Seismic Walkdown Checklist (SWC)

Project: Callaway SWEL

Equipment ID No.: EJFIS610

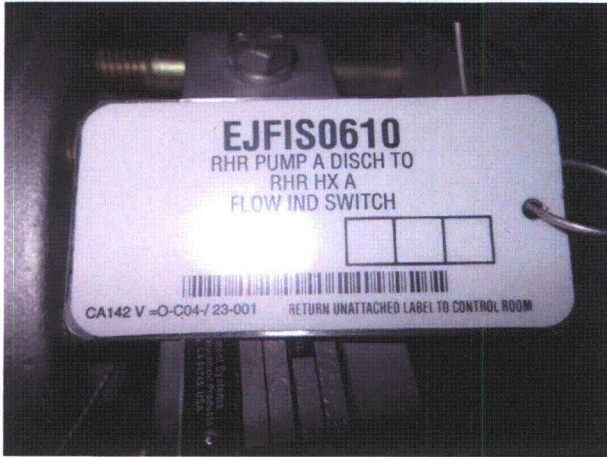
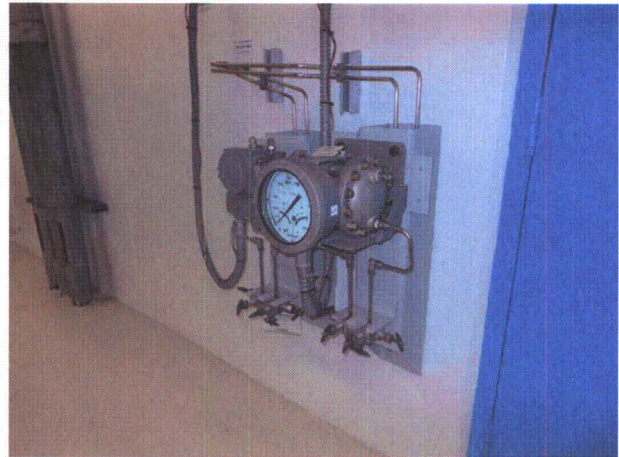
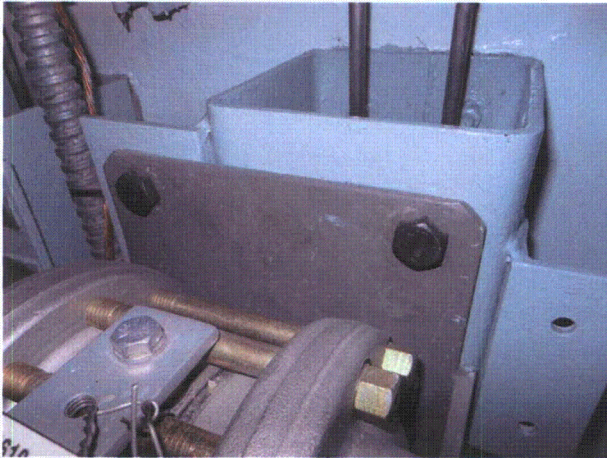
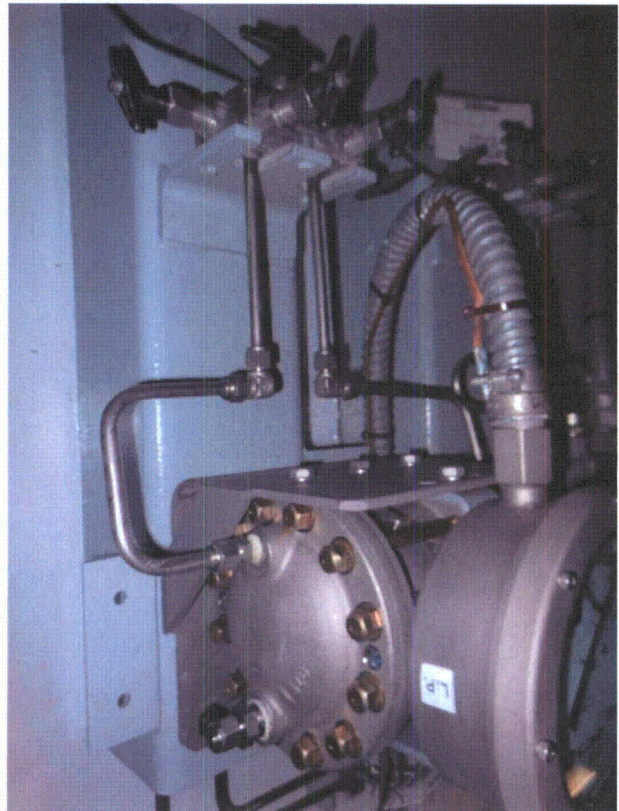
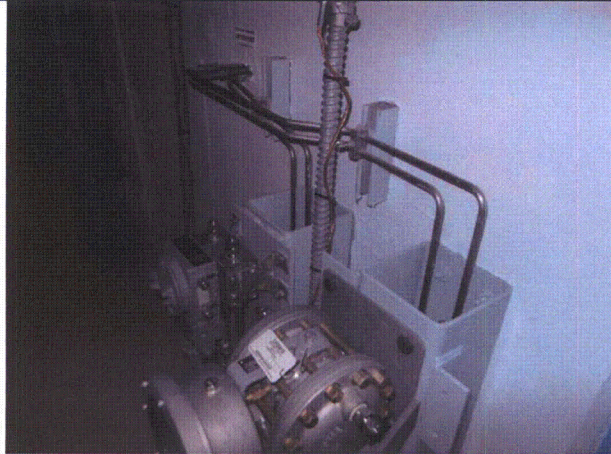
<i>Instrument's mounting frame is bolted to a 6x6 TS and 3x3 angle. The angle is welded to the TS. The TS is anchored to the wall by expansion anchors, typical anchor detail. OK per J-27D26, and J-27G02.</i> | Yes |

7. Are soft targets free from impact by nearby equipment or structures? Yes
Tubing between EJFIS610 and EJFT618 with 3/16" gap both instruments are anchored to wall, therefore O.K.
8. Are overhead equipment, distribution systems, ceiling tiles and lighting, and masonry block walls not likely to collapse onto the equipment? Yes
9. Do attached lines have adequate flexibility to avoid damage? Yes
10. Based on the above seismic interaction evaluations, is equipment free of potentially adverse seismic interaction effects? Yes

Equipment ID No.: EKJ04A

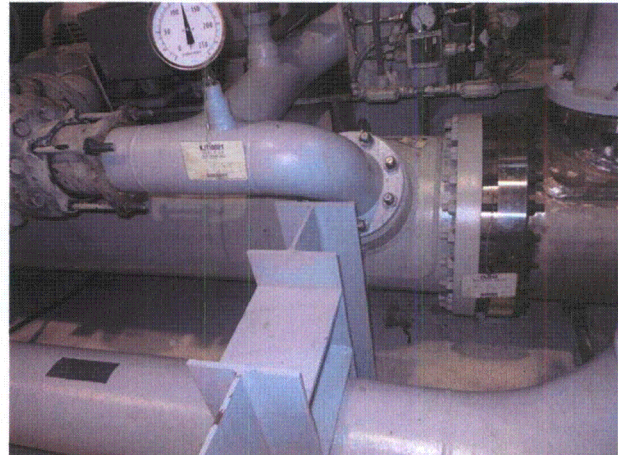
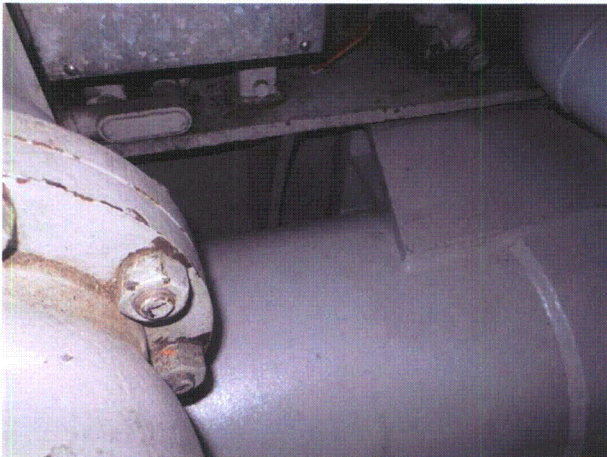
2. Is the anchorage free of bent, broken, missing or loose hardware? Yes
Mounted on Diesel skid (welded).

One support is notched to avoid contact with heat exchanger.

Equipment ID No.: EKJ06A

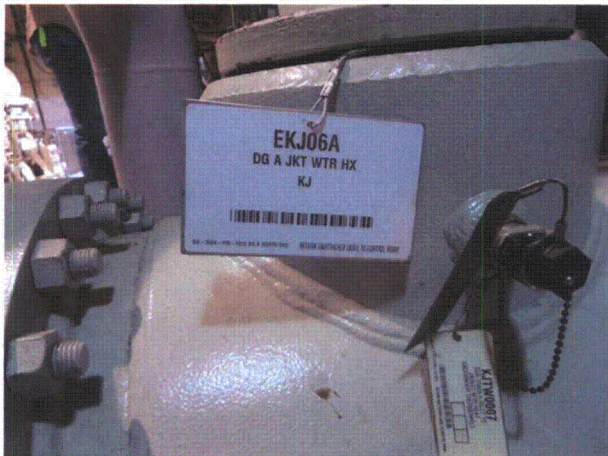
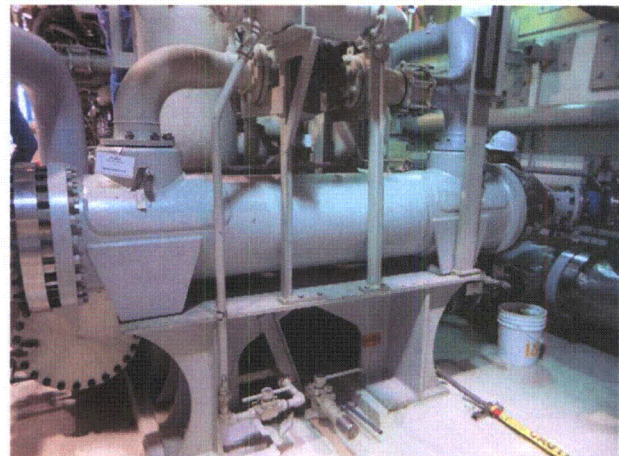
2. Is the anchorage free of bent, broken, missing or loose hardware? Yes
One bolt is threaded less than flush, no concern.

7. Are soft targets free from impact by nearby equipment or structures? Yes
Up against a support leg but it is very rigid to move, not a seismic concern.
8. Are overhead equipment, distribution systems, ceiling tiles and lighting, and masonry block walls not likely to collapse onto the equipment? Yes
9. Do attached lines have adequate flexibility to avoid damage? Yes
10. Based on the above seismic interaction evaluations, is equipment free of potentially adverse seismic interaction effects? Yes

Equipment ID No.: EMFT917A

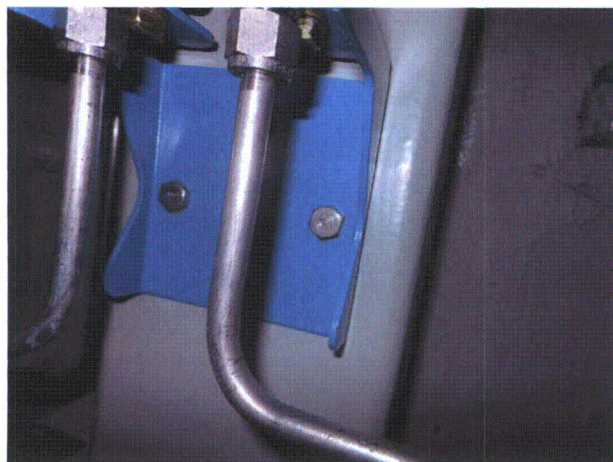
5. Is the anchorage configuration consistent with plant documentation? (Note: This question only applies if the item is one of the 50% for which an anchorage configuration verification is required.) Yes
Transmitter is mounted to a tube stanchion by 4 bolts and the stanchion is anchored to the concrete wall via the standard 3/8" bolting. OK per J-27D01, J-27G22, and J-27G02.

7. Are soft targets free from impact by nearby equipment or structures? Yes
Nearby pipe with adequate gap.
8. Are overhead equipment, distribution systems, ceiling tiles and lighting, and masonry block walls not likely to collapse onto the equipment? Yes
Overhead emergency light is adequately anchored to wall.
9. Do attached lines have adequate flexibility to avoid damage? Yes
Flex conduit and tubing attached to some mounting structure.
10. Based on the above seismic interaction evaluations, is equipment free of potentially adverse seismic interaction effects? Yes
